DRAINAGE AND TRANSPORTATION INFORMATION SHEET

Project Title: Musket Development Building Permit #: _____ City Drainage #: _____

**MUSKET DEVELOPMENT
8TH STREET AND BELLAMAH
ALBUQUERQUE, NEW MEXICO**

**RE: Musket Development
1615 8th St NW
Grading and Drainage Plan
Engineers Stamp Date 5/14/15 (J14D175)**

MUSKET DEVELOPMENT 1615 8th STREET NW	DRAWN BY pm
	GRADING AND DRAINAGE PLAN	DATE 5-19-15
	TIERRA WEST, LLC 5571 MIDWAY PARK PL. NE ALBUQUERQUE, NEW MEXICO 87109 (505) 858-3100 www.tierrawestllc.com	DRAWING 2015014-GR
		SHEET # GR-1
		JOB # 2015014

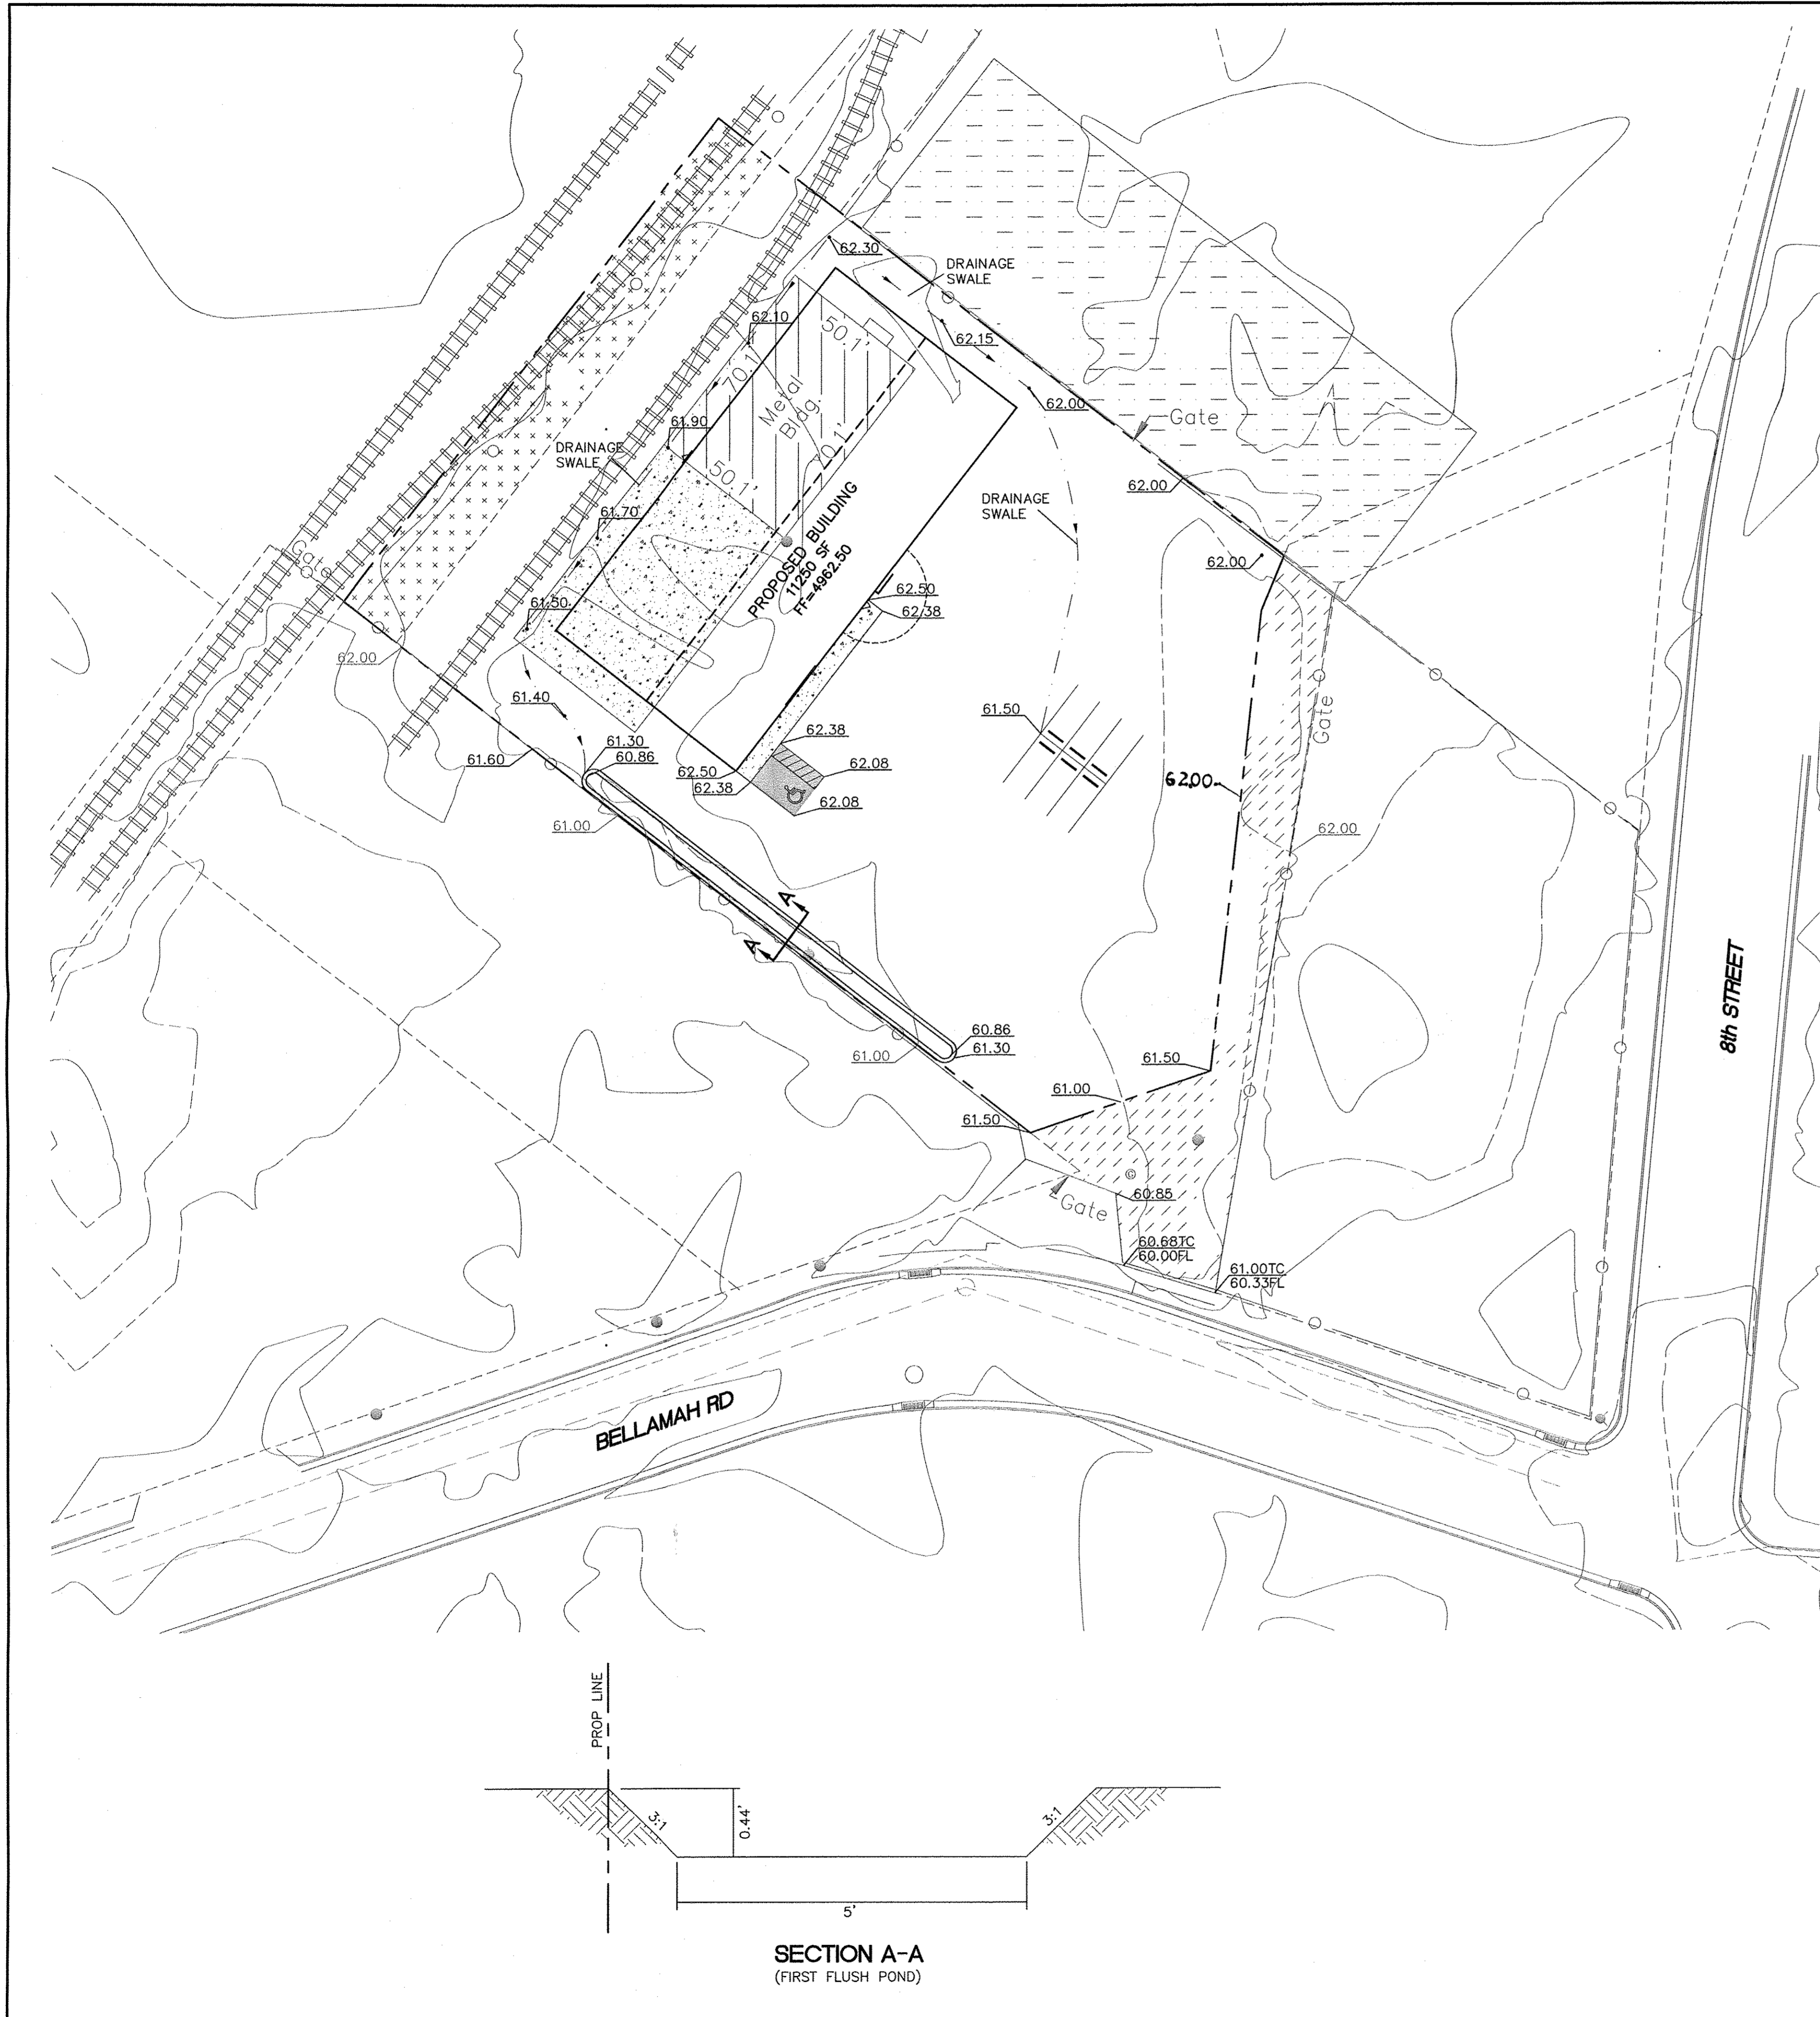
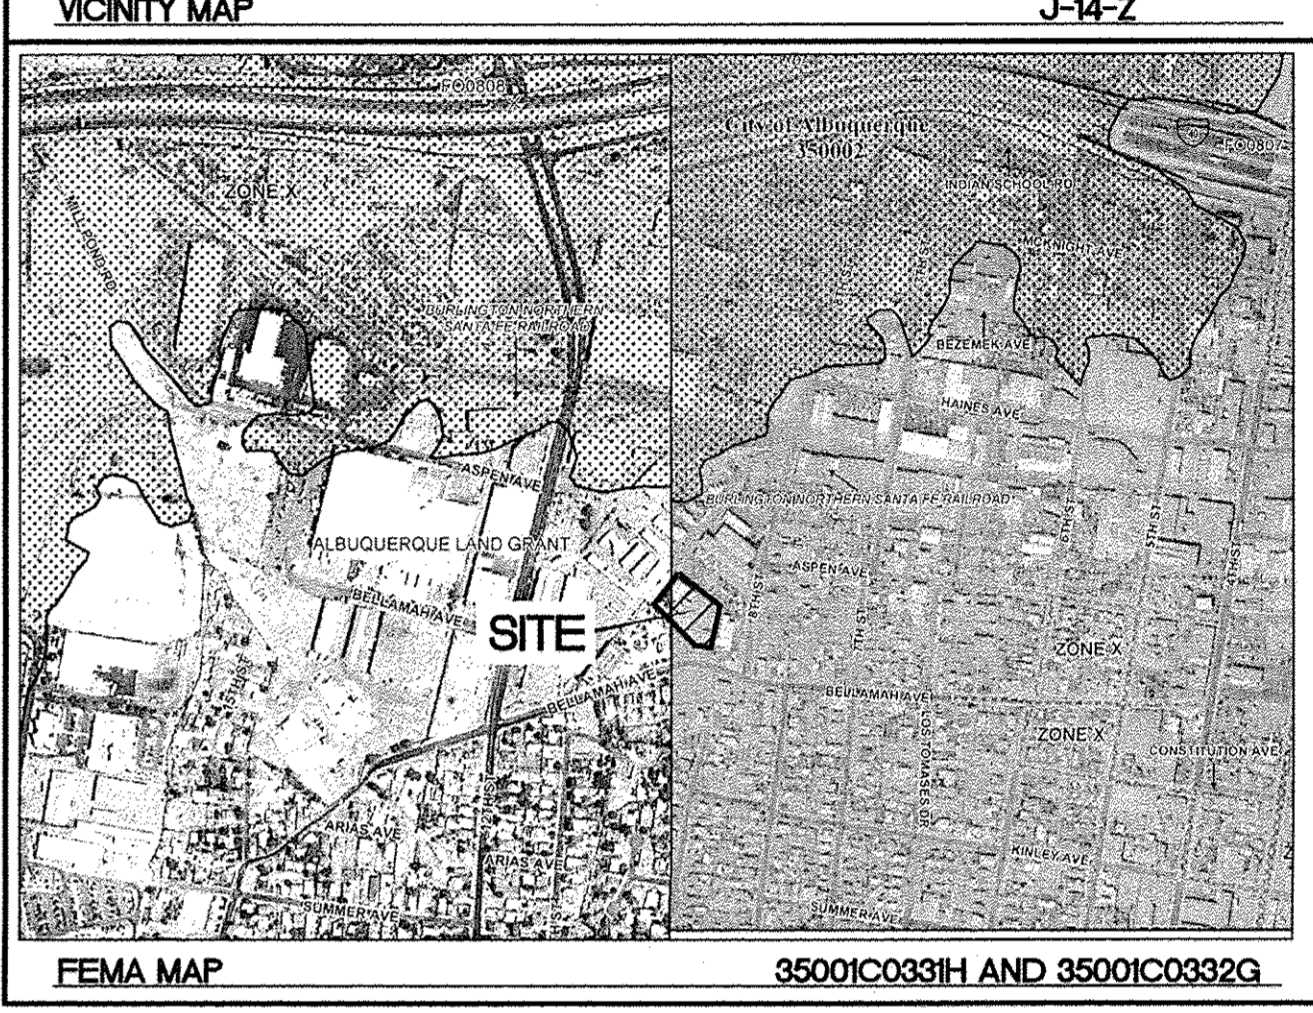
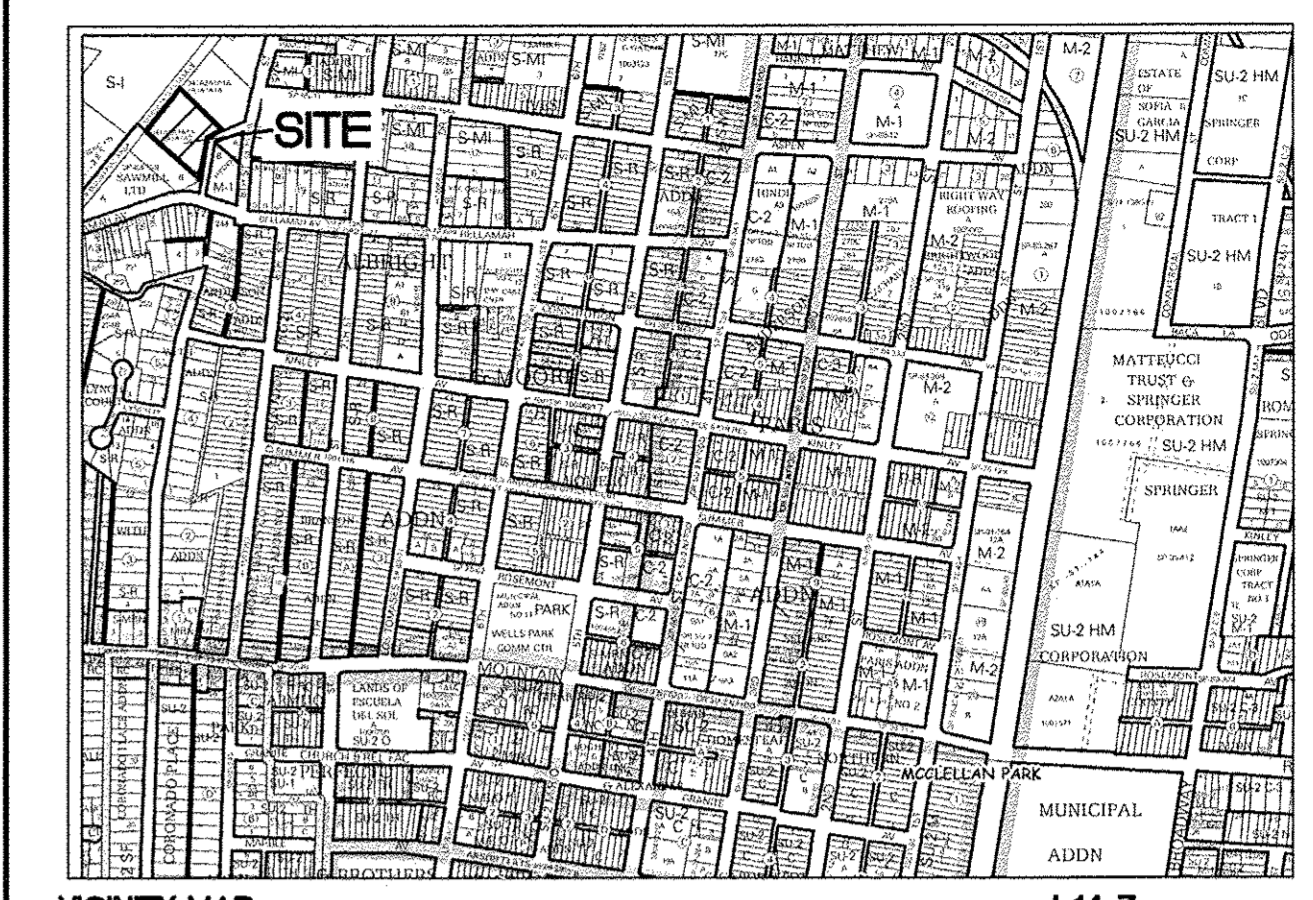
- It appears curbing is placed around the First Flush Pond, if so, how will flows enter or exit this area?
- A cross lot drainage agreement is needed from the owners to the left of this site.
- Provide a scale and north arrow.
- How are flows from the roof directed away from the building? Show roof flows.
- Provide spot elevations in Bellamah.
- How are flows affected around this site?
- Provide profiles for the swales.
